Comments to 802.1CM Specification draft

March 2016
Tero Mustala
Eero Ryytty

Figure 5-0, Functional Parts of a Cellular Base Station

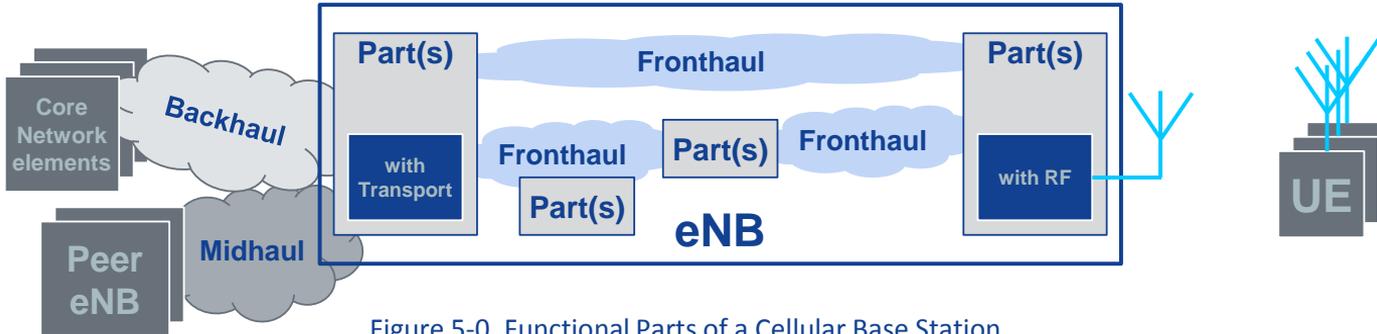
This standard is focusing on the requirements of fronthaul and meeting these requirements by a bridged network. This clause describes the fronthaul requirements to be fulfilled by a bridged network. Fronthaul is connectivity between functional parts of a cellular Base Station (eNB) like illustrated in Figure 5-0 below. Fronthaul has traditionally been implemented with point-to-point connections based on CPRI standard. In this standard same interconnectivity will be defined using bridged Ethernet, but in later stage also other fronthaul classes with relaxed requirements will be defined.

Figure 5-2—Fronthaul network

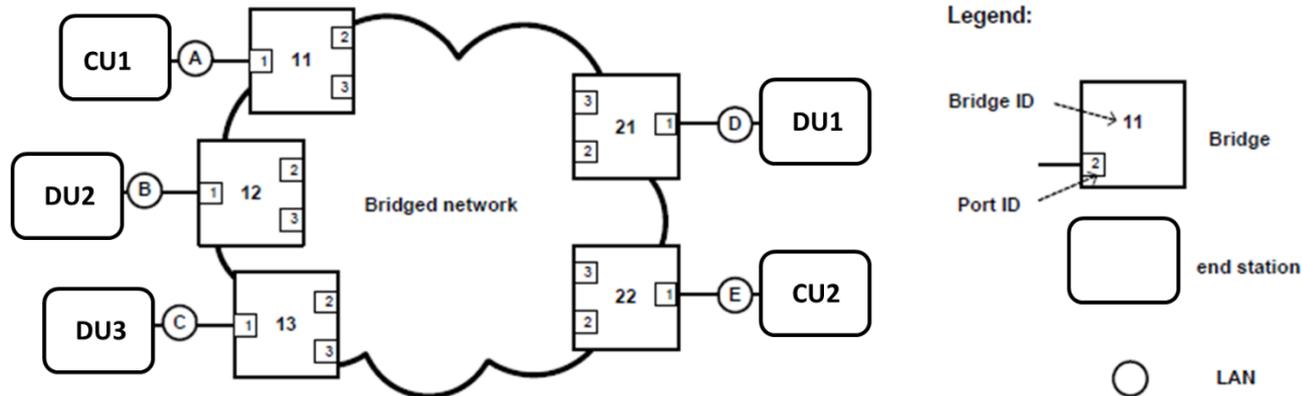
A fronthaul network is a network providing the fronthaul connections, e.g., a bridged network as shown in Figure 5-2. CUs and DUs are end stations, which are interconnected by a bridged fronthaul network. Bridges depicted in the figure are Edge Bridges and Port 1 of the Bridges are Edge Ports. The fronthaul network provides point-to-point, point-to-multipoint, multipoint-to-point, or multipoint-to-multipoint connections between the CUs and DUs as required for the fronthaul connections.
